Description:	Review amended site and related plan review for RV parking spaces and a pet relief area on the property at 9650 S. 20^{th} St.			
Applicant(s):	Sara Harville, CESO, Inc.			
Address(es):	9650 S. 20 th St. (5 th Aldermanic District)			
Suggested Motion:	That the Plan Commission approves the amended site and related plans for the addition of RV parking spaces and a pet relief area at Love's Travel Stop, an existing business located at 9650 S. 20th Street with the following conditions:			
	 That all relevant Code requirements remain in effect. That all new mechanical equipment, transformers, and utility boxes shall be screened from view. That this approval by Plan Commission shall expire within twelve (12) months after the date of approval if a building permit has not been issued. 			
Owner(s):	Love's Travel Stops & Country Stores, Inc.			
Tax Key(s):	904-9000-001			
Lot Size(s):	13.246 acres

Amended Site Plan Review - Love's Travel Stop

Narrative of Plan Revisions - Love's Oak Creek, WI RV Parking Addition

OVERALL SITE PLAN

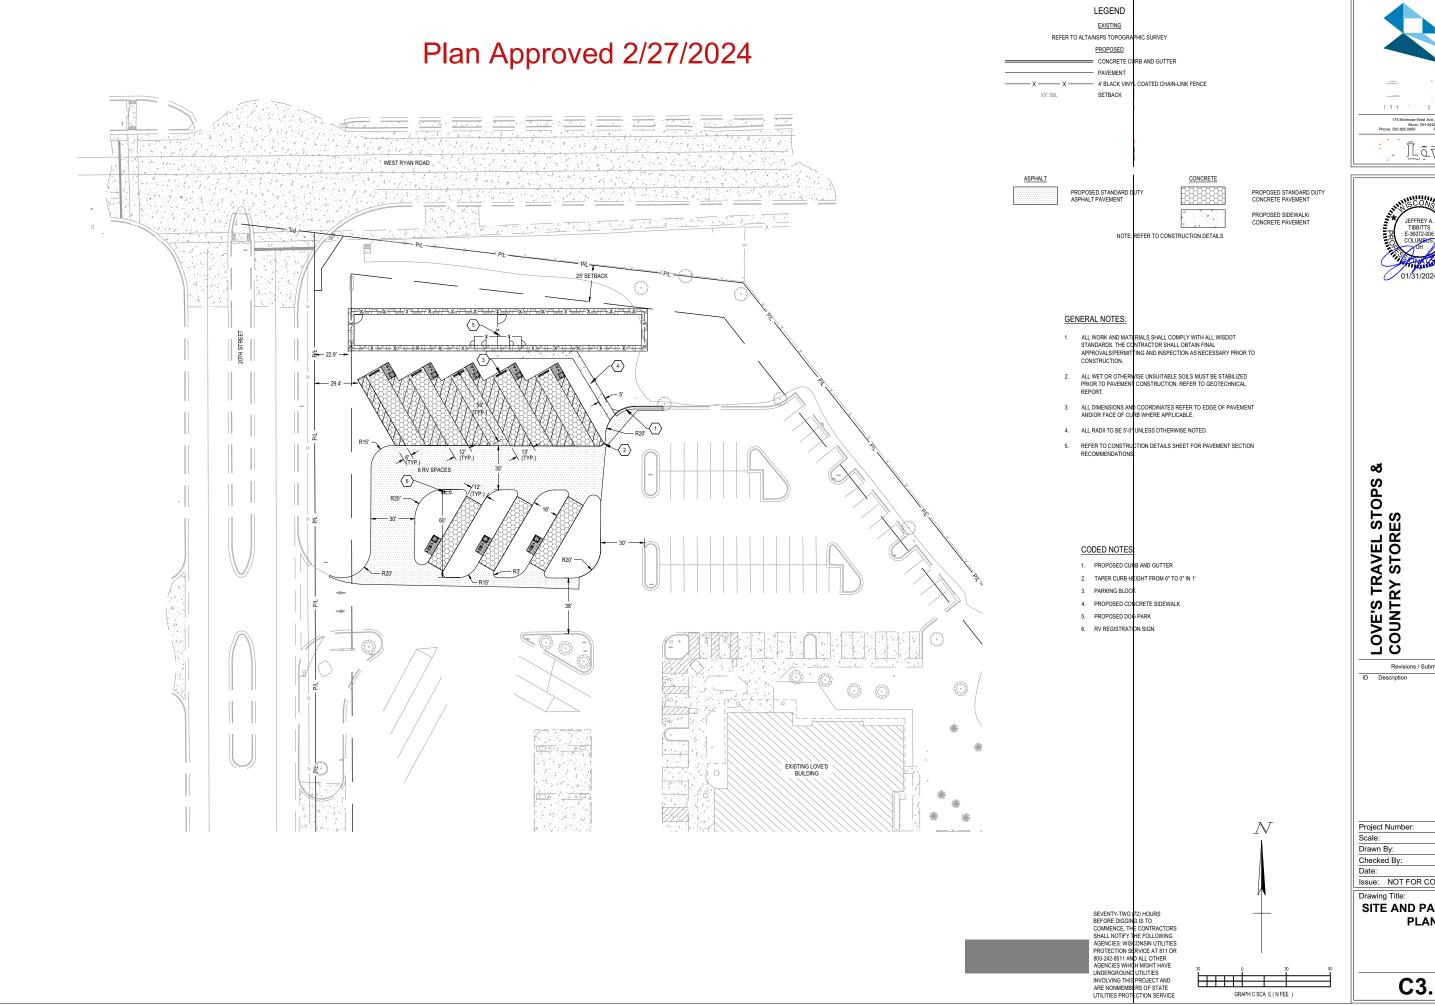
SHEET C3.0 - OVERALL SITE PLAN

- The five northern RV spaces were removed, and the three pull-thru spaces were converted into four back-in RV parking spaces. This reduces the amount of proposed impervious area to below 5,000 SF and bioretention is no longer required on the site.

- 2. Because the bioretention system is no longer required, the proposed dog park was shifted east to minimize disturbance on site. The dog park dimensions were also reduced to the minimum permitted by Love's standards to further minimize disturbance. The dog park length was reduced from 200 feet to 70 feet, but the maximum width increased from 25 feet to 42.83 feet. The total area of park changed from 5,000 SF to approximately 3,000 SF.

- The access drive to the north RV spaces was removed since there is now only one row of parking stalls. If the RV stalls prove popular, Love's could look to add additional spaces to the north in future, along with an access road that would ring the back-in stalls.

- 4. Total open space provided increased from 4.571 acres (31.9% of the site) to 5.601 acres (39.1%). The minimum open space requirement is 30%.

SITE AND PAVEMENT PLAN

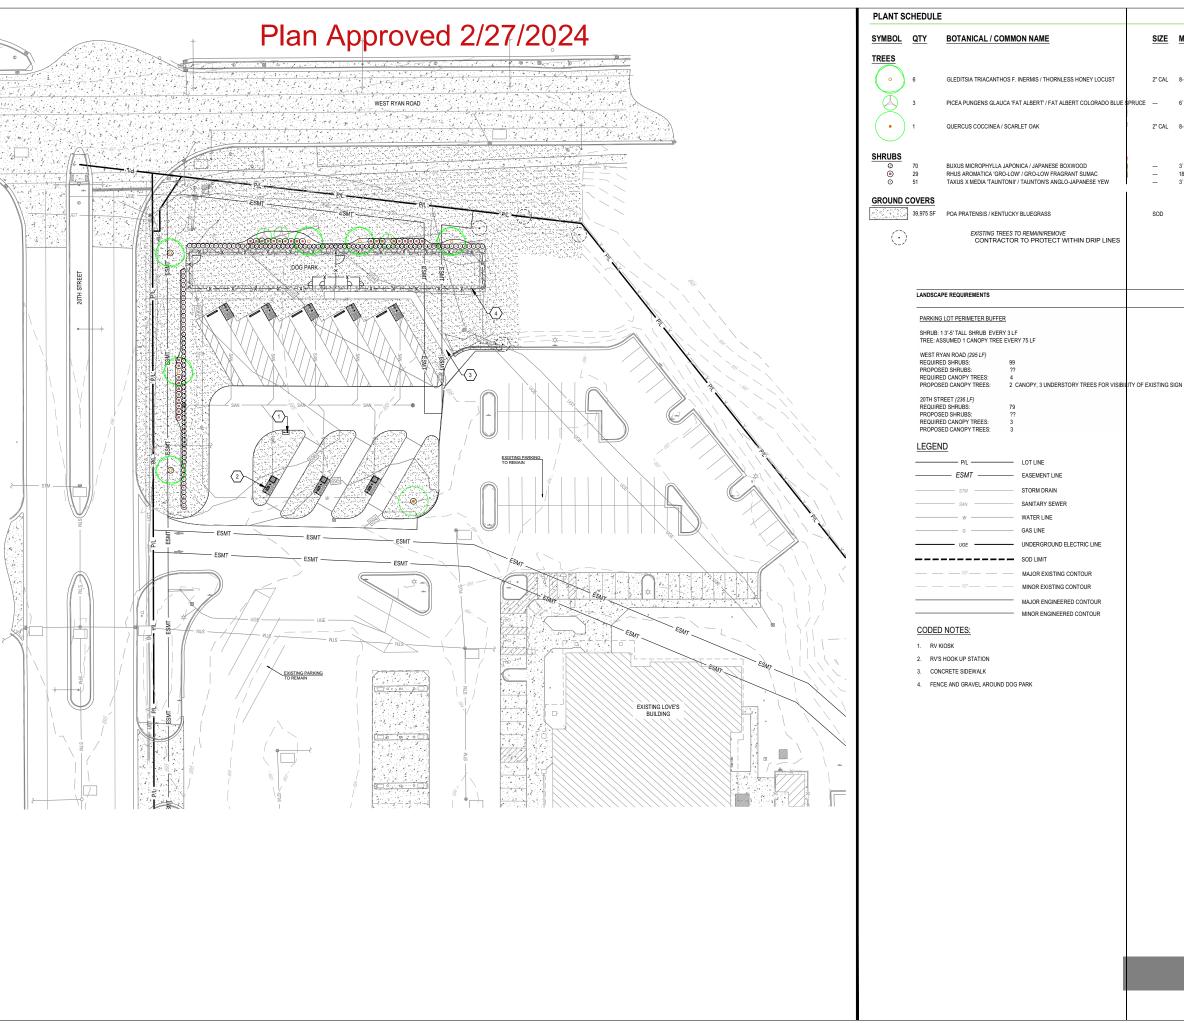
SHEET C3.1 - SITE AND PAVEMENT PLAN

- The five northern RV spaces were removed, and the three pull-thru spaces were converted into four back-in RV parking spaces. This reduces the amount of proposed impervious area to below 5,000 SF and bioretention is no longer required on the site.
- 2. Because the bioretention system is no longer required, the proposed dog park was shifted east to minimize disturbance on site. The dog park dimensions were also reduced to the minimum permitted by Love's standards to further minimize disturbance.
- 3. The access drive to the north RV spaces was removed since there is now only one row of parking stalls.
- 4. The proposed parking stalls and associated utility pad pavement remains concrete, as was originally

Supporting Your Vision Seamlessly proposed, but the space between the RV stalls has been converted to grass. This was done to further increase the open space on site.

5. An increased portion of the existing asphalt pavement will be replaced to ensure positive drainage on the site.

PLANTING PLAN

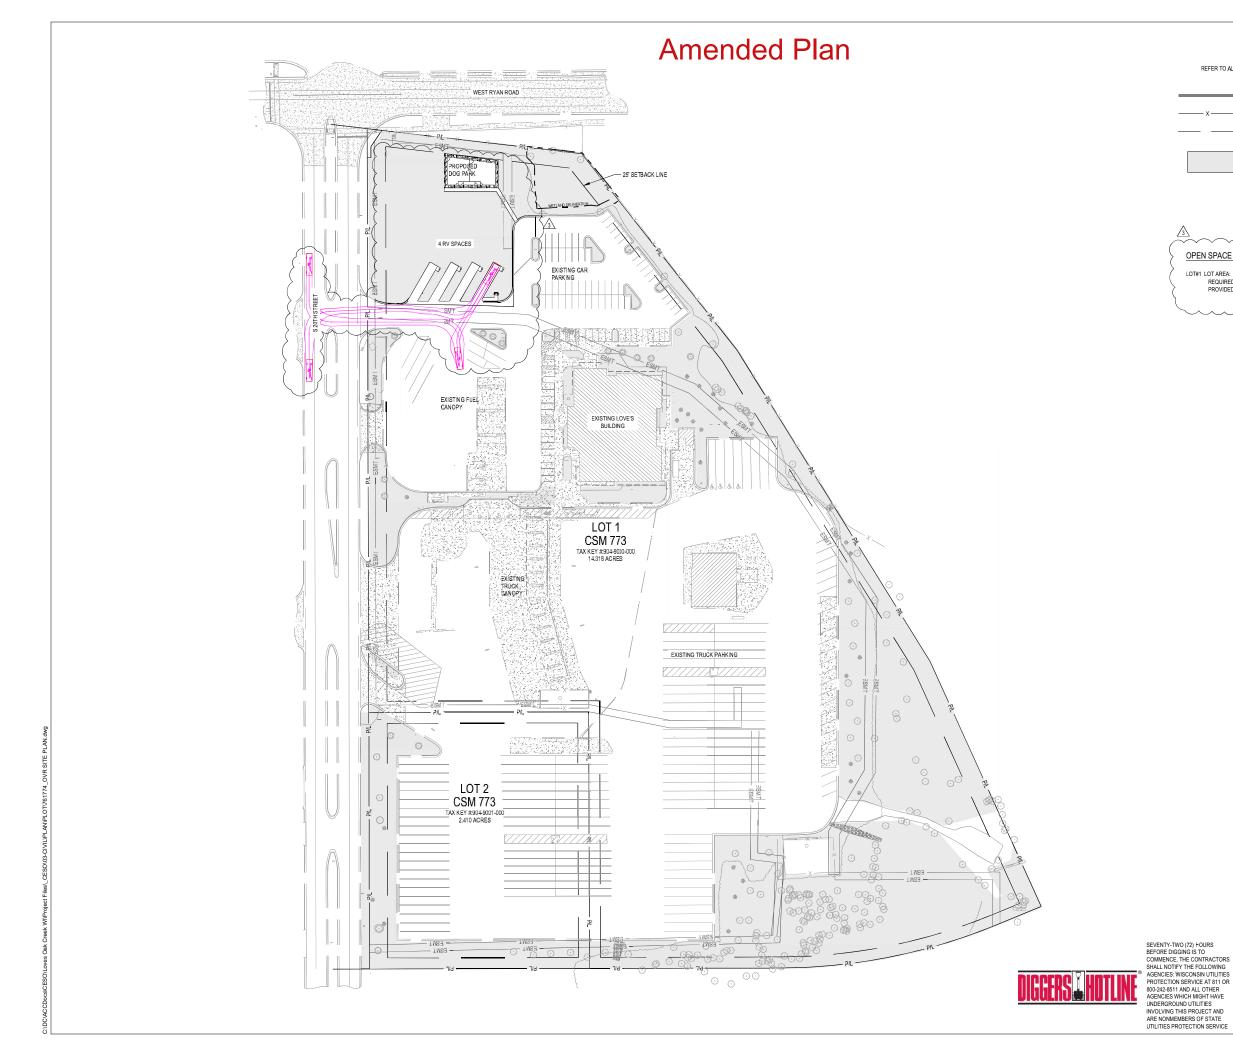
SHEET L1.0 - PLANTING PLAN

- 1. The five northern RV spaces were removed, and the three pull-thru spaces were converted into four back-in RV parking spaces. Sod was added between the RV parking stalls to further increase pervious area on site.

- 2. The proposed dog park was shifted east and the dimensions were reduced to further minimize disturbance.
- 3. The access drive to the north RV spaces was removed since there is now only one row of parking stalls.

- 4. The route of the water service line to the individual RV parking stalls as well as the dog park has been adjusted based on the new locations of the improvements.

- 5. Sanitary sewer service to the individual RV parking stalls has been removed.
- 6. Details for the bioretention area have been removed since this is no longer a requirement for the site.

- 7. The landscape buffer along 20th Street was reduced due to a reduction in the limits of disturbance. Since the improvements do not extend as far north along 20th Street as originally proposed, the required number of plantings was reduced from 79 shrubs and 3 canopy trees to 24 shrubs and 1 canopy tree. 25 shrubs and 1 canopy tree are proposed (a reduction from 79 shrubs and 3 trees).

- 8. The landscape buffer along W. Ryan Road remained unchanged in the number of plantings proposed (99

- shrubs, 2 canopy trees and 3 understory trees), but it did shift south slightly to reflect the proposed limits of disturbance.
- Plantings and sod areas were revised to remain within the limits of disturbance, which shrunk due to the reduction in the number of parking spaces and the shifting of the dog park towards the east.
- 10. The Plant Schedule was updated to reflect the latest number of proposed trees, shrubs and sod area.
